# RENESAS TECHNICAL UPDATE

Product Category	Package	Document No.	TN-WRP-A015A/E	Rev.	1.00
Title	Standardization of moisture-proof aluminum bags and addition of drying agent specifications (expansion of target products)		Information Category	Packing Change	
Applicable Product	All products using the target parts below	Lot No.	Reference Document

[A-1]  
For a tray

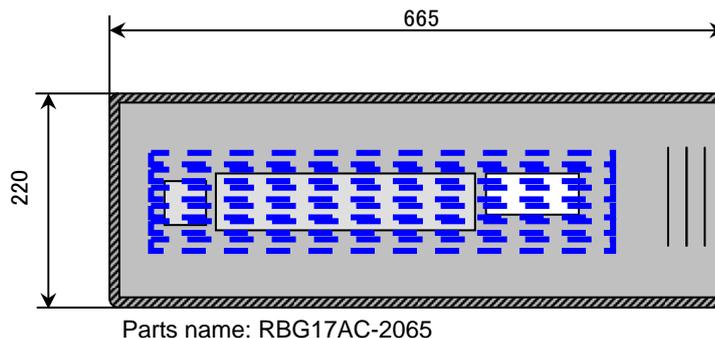
(1) The size and specifications of the moisture-proof aluminum bags will be changed. (Detail about the size are shown in the table and figures below.)

(2) Instructions about opening a bag will be standardized and attached to the moisture-proof aluminum bags.

<Added specification 1>

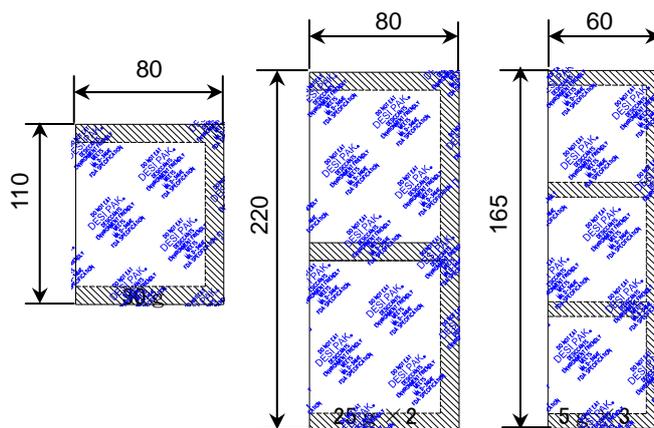
**4.2.1 The table below shows the scope of the newly added specifications of the drying agents.**
